**Date:** Monday 18 to Friday 22 November 2024  
**Time:** 9.30am  
**Meeting room:** TBA  
**Venue:** Level TBA, Auckland Town Hall  
301/317 Queen Street, Auckland

**PRIVATE PLAN CHANGE 94**  
**APPLICATION MATERIAL VOLUME 3**  
**WAIRAKA PRECINCT IN CARRINGTON ROAD,**  
**MT ALBERT**  
**MINISTRY OF HOUSING AND URBAN**  
**DEVELOPMENT – HANNAH MCGREGOR**

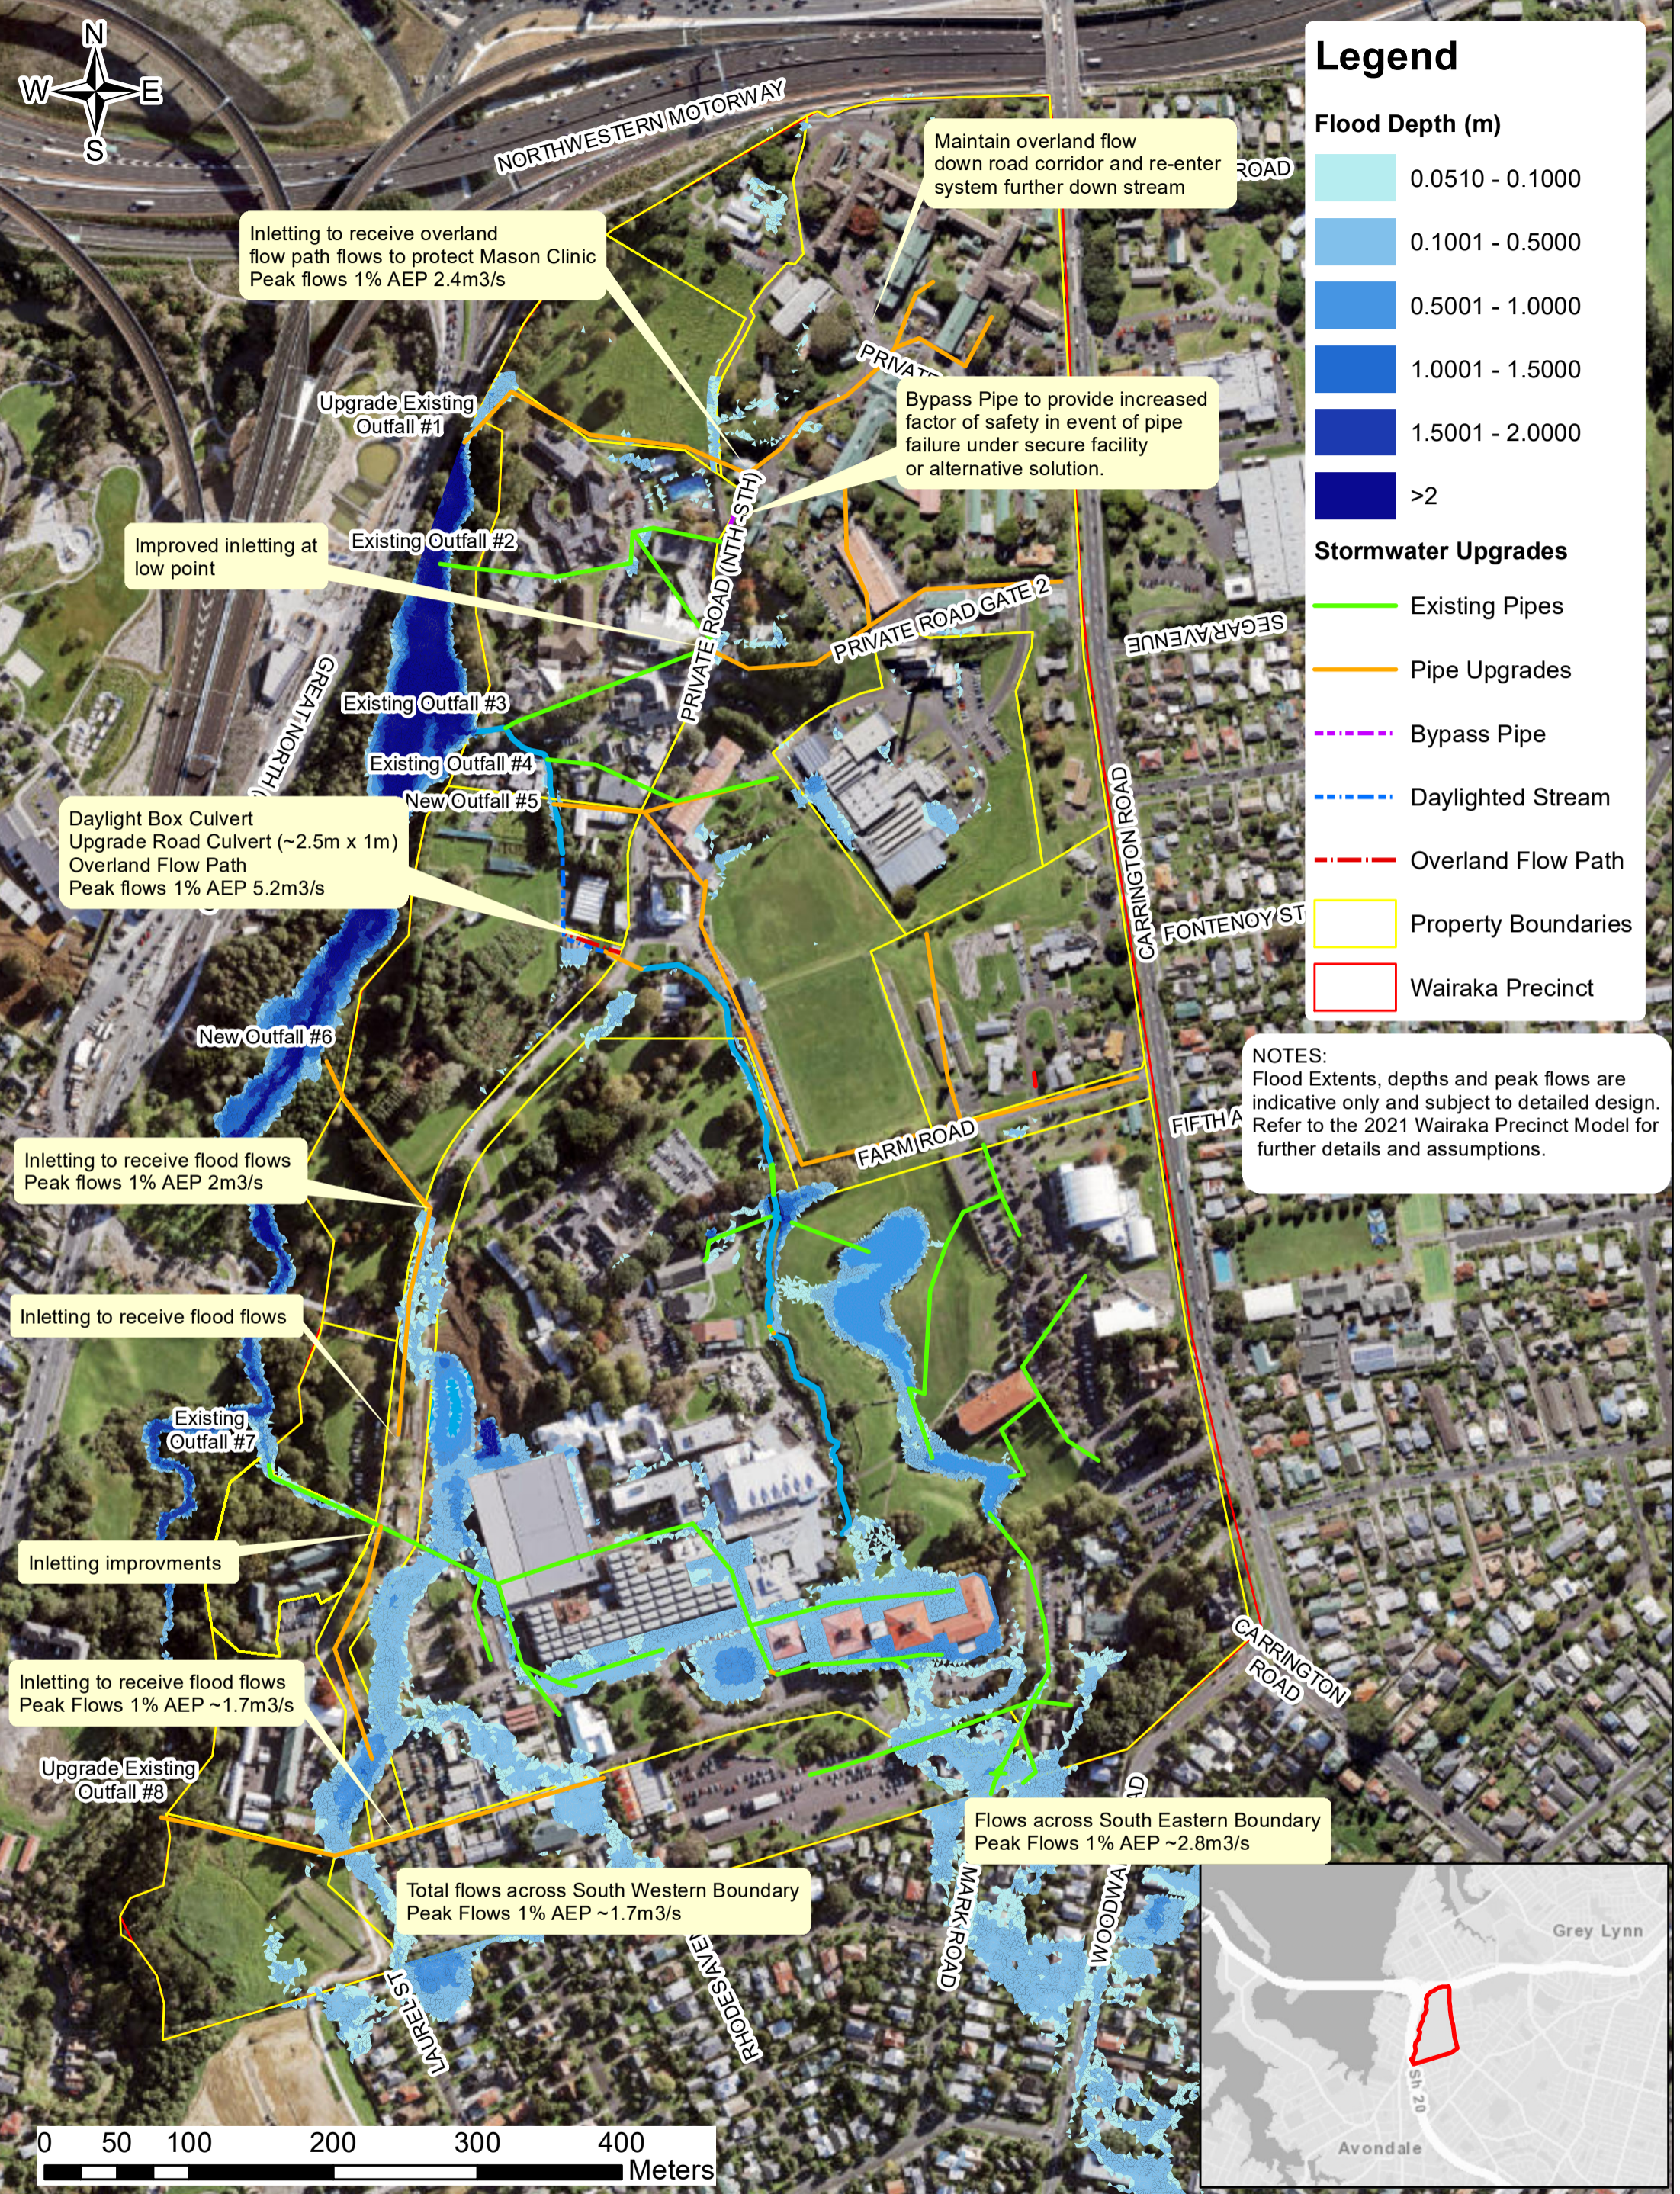
<b>Question</b>	OS3
<b>Specific request</b>	Please provide a clear delineation showing which areas of proposed open spaces are required / proposed for stormwater purposes and which areas are proposed for recreation purposes (neighbourhood, suburb and sports park).
<b>Reasons for request</b>	A clear distinction needs to be made in respect of the types of open space to be provided. For instance, drainage reserves should be shown as such on the precinct plan and should take into account existing or potential flood areas (reference the Wairaka Precinct SMP). Note, in that respect, that Figure 8.1 in the Applicant's Wairaka Precinct: Stormwater Management Plan prepared by MPS Ltd (part of the lodgement document bundle) shows a considerable reduction in flooding-affected areas. As part of the response to this RFI confirmation is sought that this accurately reflects the potential for flooding on proposed open space land that is identified as subject to flooding on the council's GIS so that the council can objectively assess its suitability for potential acquisition for open space purposes.

- 17 The Wairaka Stream is kept in its existing / natural state and is considered to have significant landscape amenity.
- 18 With that exception, there is no other stormwater function in Knoll park.

- 19 There is one minor overland flow path through this open space area in the south eastern corner, refer to the maps provided as set out in the stormwater impacts section of this response below.

### Operative Precinct plan 1 notations

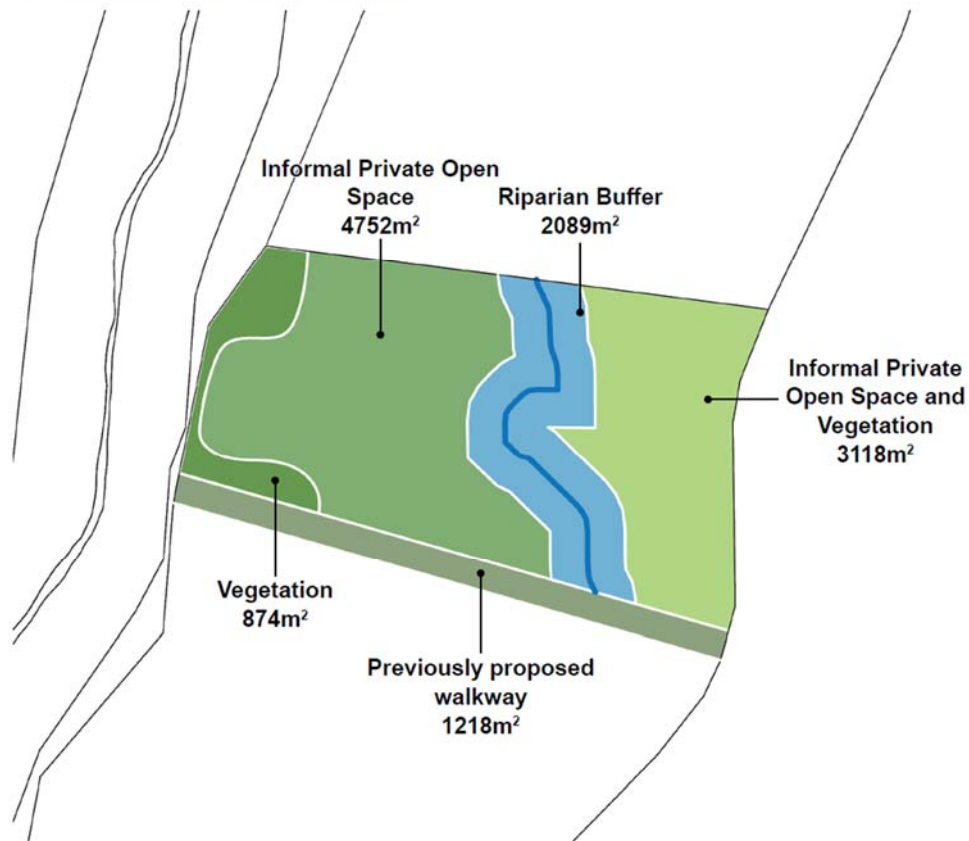
As the Crown currently holds 26.5 hectares of land within the Precinct, there is no question that it will be possible to provide equivalent private open space and an equivalent shared path connection on the Housing Development Land.

- 5 The below illustrates how this is achieved, comparing the operative Precinct plan 1 notations to that proposed through this plan change.

- 6 The operative Precinct plan 1 provides for a 1.2ha area of "Key open space (private)" on the land adjoining the southern former Mason Clinic boundary. This land was not intended nor identified on the Precinct plan for use as public open space.

Figure 3: PC78 proposed zoning to the east of Carrington Road opposite the site showing the extent of THAB, MH-U and Special Purpose Healthcare Facility and Hospital zones.

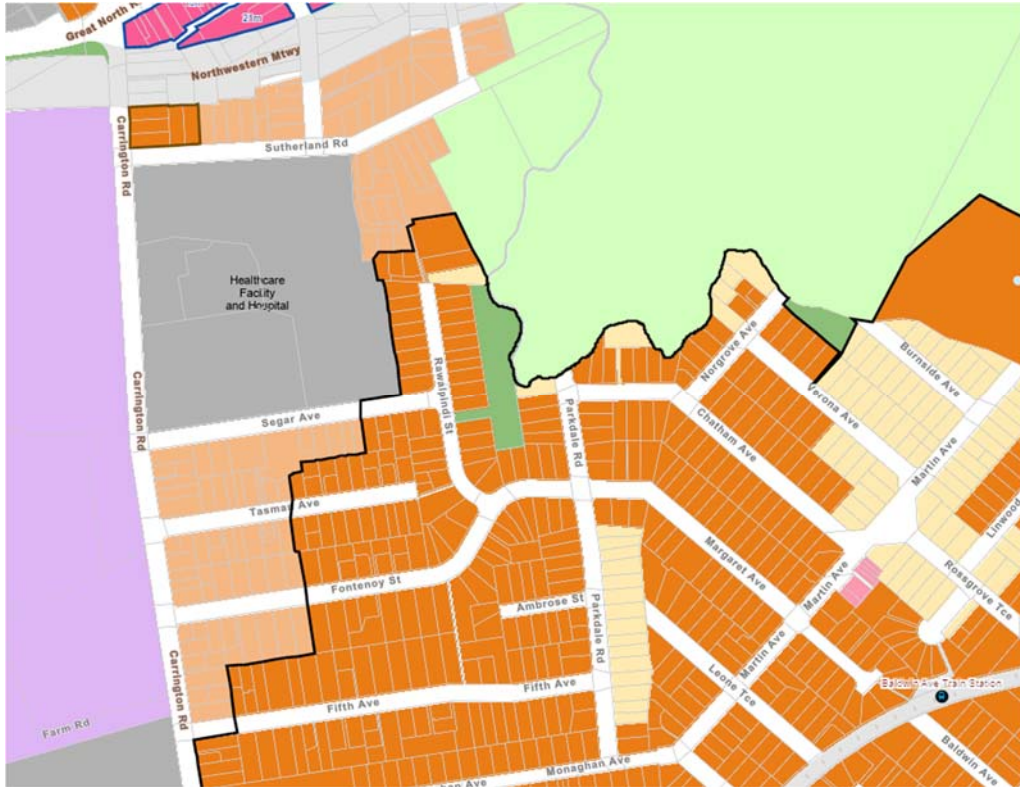
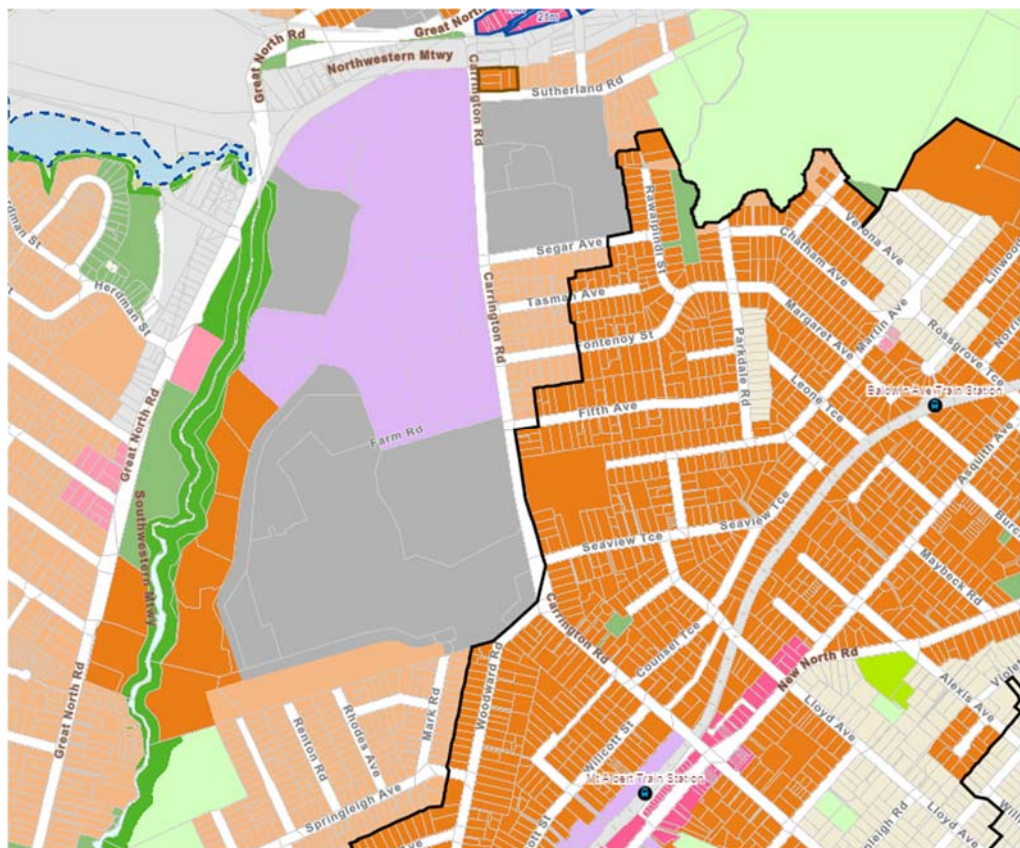
- Question** L2 & L3
- Specific request L2** Please provide an additional assessment Viewpoint and related photo simulations that address views across the Plan Change site from closer to Woodward Road (see Figure 1 below).
- Reasons for request L2** Figure 1 and VS1-7 address only the lower end of Carrington Rd, not development to increased heights down most of its length. Although VS7 addresses the relationship of MHU development to Height Area 4 (in particular) the relationship of that same Height Area to the (proposed) THAB Zone further south along Carrington Rd is still relevant to the assessment of effects.
- The elevated and 'introductory' nature of views across the site from near Woodward Road mean that this part of Carrington Rd is particularly important in terms of public interaction with future development across it.

- 11 An approximately 8m width of road widening is proposed along Carrington Road with the widening taken from along the precinct's eastern boundary. The widening provides for enhanced cycle, pedestrian, and public transport corridors along the key arterial. The Crown has funded Auckland Transport to upgrade Carrington Road through the Infrastructure Acceleration Fund, including for dedicated bus and cycle lanes, with works programmed to start in 2025. These works have not been modelled in the visual simulations but the additional 8m road corridor width is shown along with the correct positioning of the potential future built edge to the Precinct.

- 12 PC78 proposes the re-zoning of existing MH-U land on the east side of Carrington Road in this location to Terrace Housing and Apartment Buildings (*THAB*), with a six storey height overlay, due to its position within the walkable catchment of the Baldwin Ave train station. The southeastern corner of the site touches the defined walkable extent of the Baldwin Avenue and Mt Albert train stations. Figures 3 and 4 below illustrate the proposed PC78 re-zoning for land along Carrington Road adjacent to the precinct.

I334.10. Precinct plans

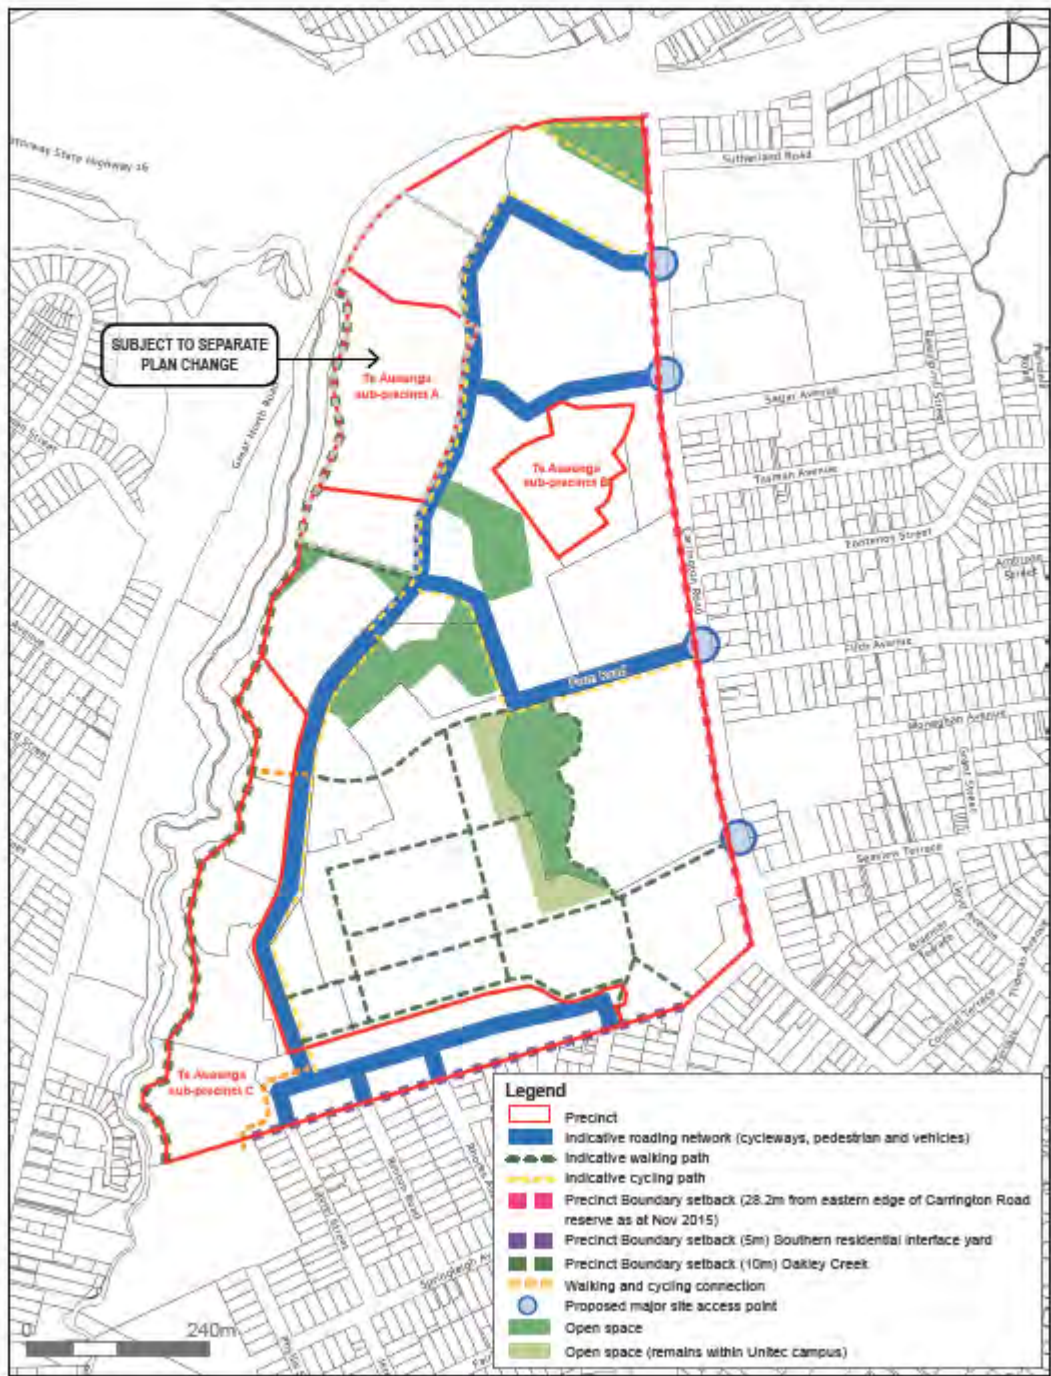
<b>Question</b>	T6
<b>Specific request</b>	Please update the proposed Precinct Plan to show a shared path connection in the northern part of the precinct, to replace the linkage lost through proposed PC75.
<b>Reasons for request</b>	It is understood that consideration has been given to an alternative shared path route. This should be illustrated on the Precinct Plan for consideration. Note that the intention to replace this path was referred to in the 11 May 2021 MHUD letter (see also OS6).
<b>Applicant response provided by</b>	John Duthie, Tattico

- 1 The Precinct plan map update provided with the clause 23 response package and reproduced for ease of reference below shows the proposed walking and cycling path connection in the northern part of the precinct. The new path section is proposed to run from approximately where the Northwestern Shared Path's boardwalk section finishes, travelling between Building 1 and the open space to connect to Carrington Road in the vicinity of the current path crossing south of Sutherland Road. The purpose of the new path section is to provide connectivity for future residents in the centre and north of the precinct.
